**MEETING OF THE PUBLIC WORKS & PROPERTY
COMMITTEE**

THURSDAY, MAY 09, 2024 AT 5:15 PM

2024 8TH STREET UTILITY AND ROADWAY IMPROVEMENTS
 CITY OF RICHLAND CENTER & CITY UTILITIES
 RICHLAND COUNTY, WISCONSIN

Aerial Image Showing the Area of Concern as a Result of the New Sidewalk Location

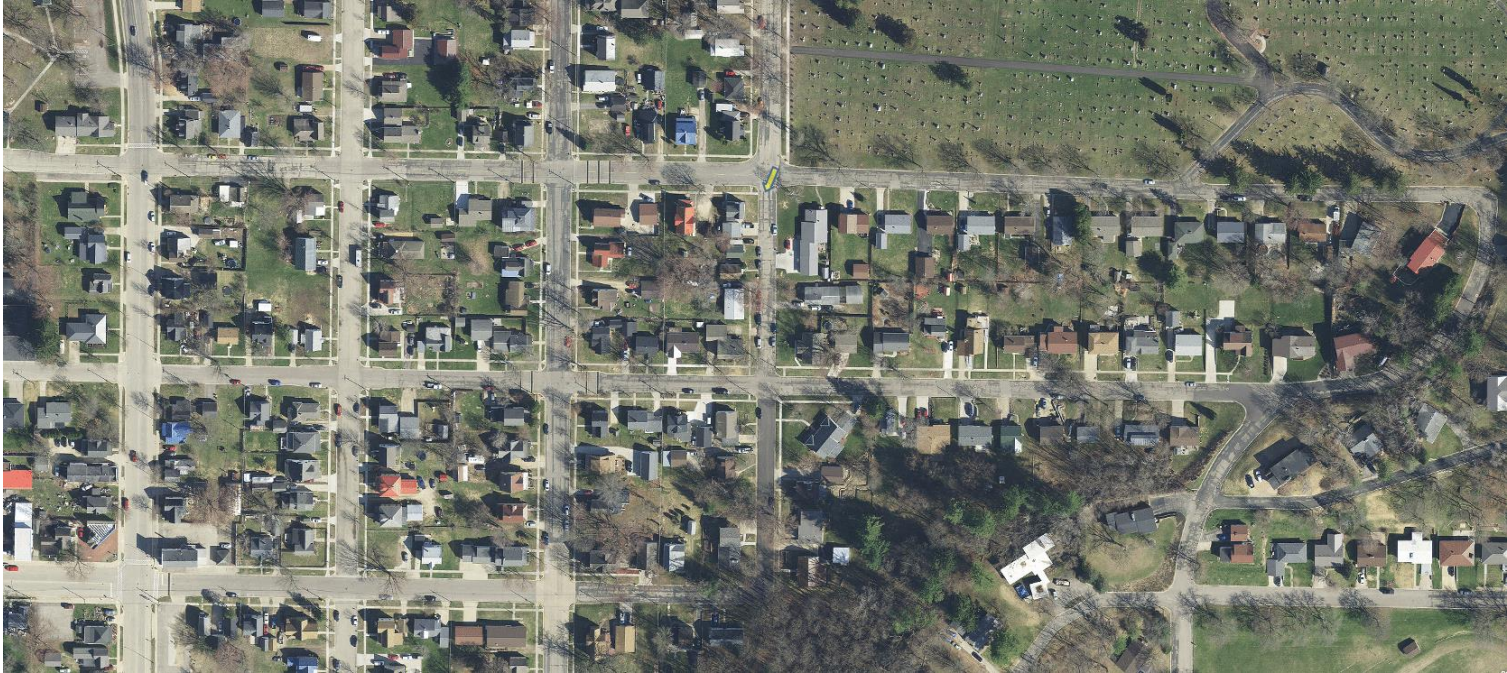
Planned sidewalk on the west side of N Park St (between 7th and 8th St intersections) will prevent resident from parking in their driveway and reduce the available yard space they are actively utilizing.

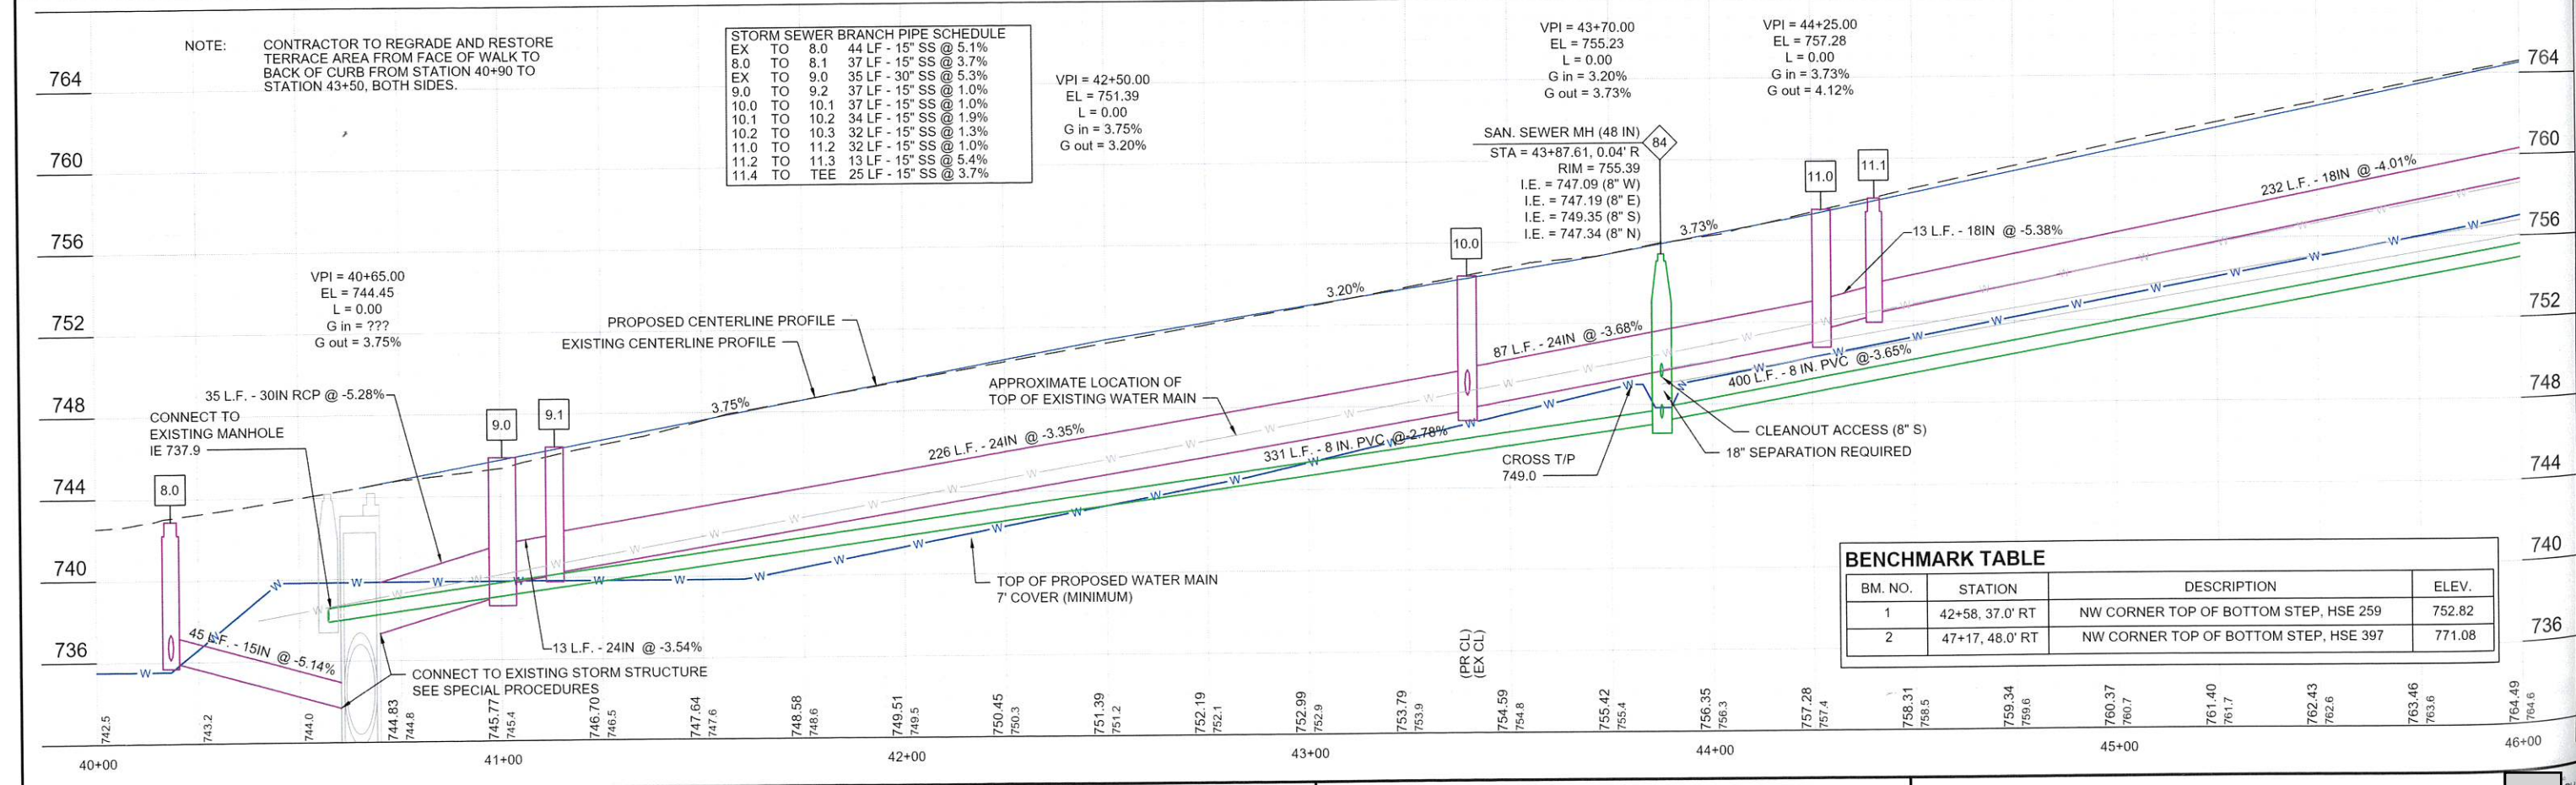
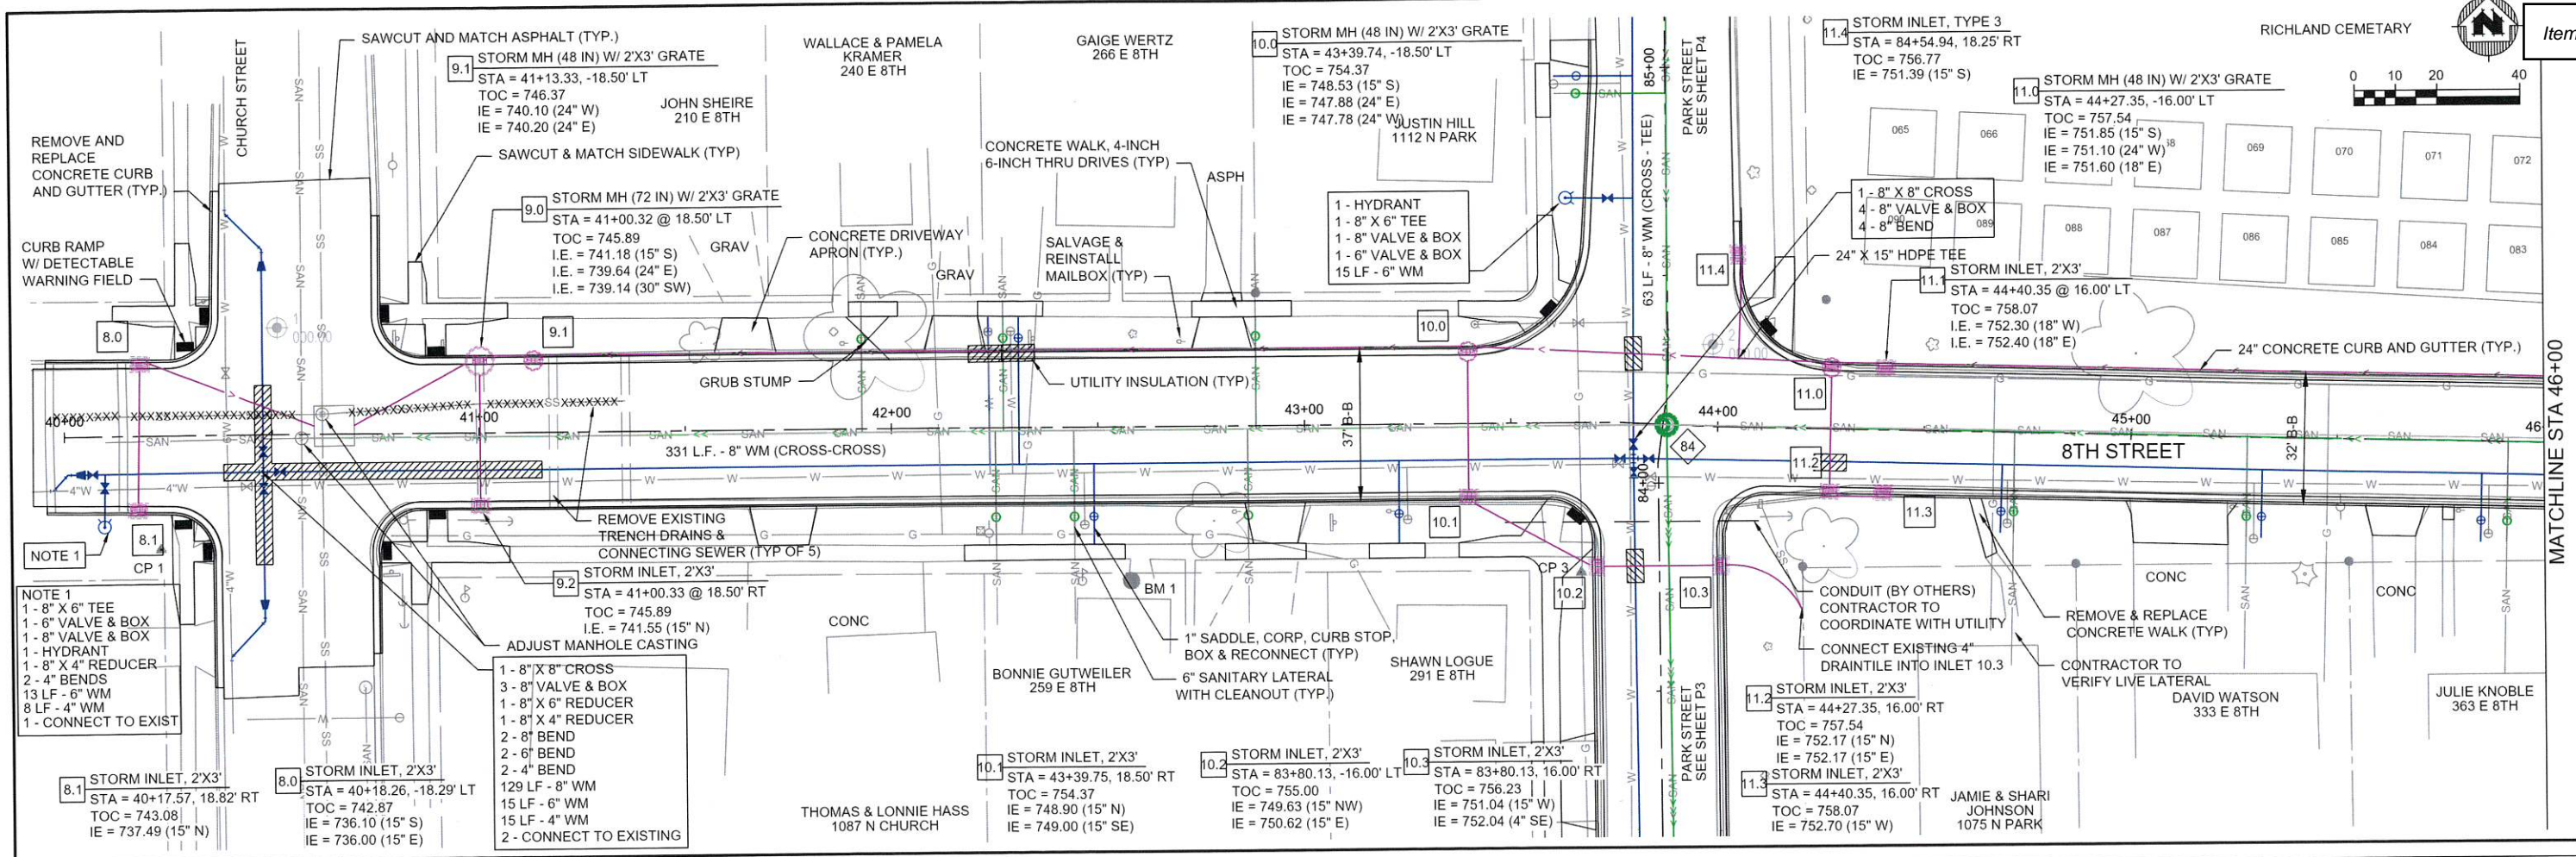
1. Remove all sidewalk on N Park Street between the 7th and 8th Street intersections.
 - a. Pedestrian safety, connectivity, flow of foot traffic, and aesthetics should be considered if this is pursued.

2. Relocate sidewalk to the west side of N Park Street.
 - a. Not advisable. Sidewalk was not planned in this location due to elevation challenges.

3. Reduce the distance between the sidewalk and curb.
 - a. Consider snow removal impact to residents when street is plowed
 - b. If pursued, determine length of vehicle(s) to be parked in driveway and whether a change in distance between the sidewalk and curb can accommodate vehicle(s).

Motion to recommend to the Common Council to consider amending the pedestrian plan for the 8th Street roadway and utility improvement project to [INSERT RECOMMENDED OPTION].
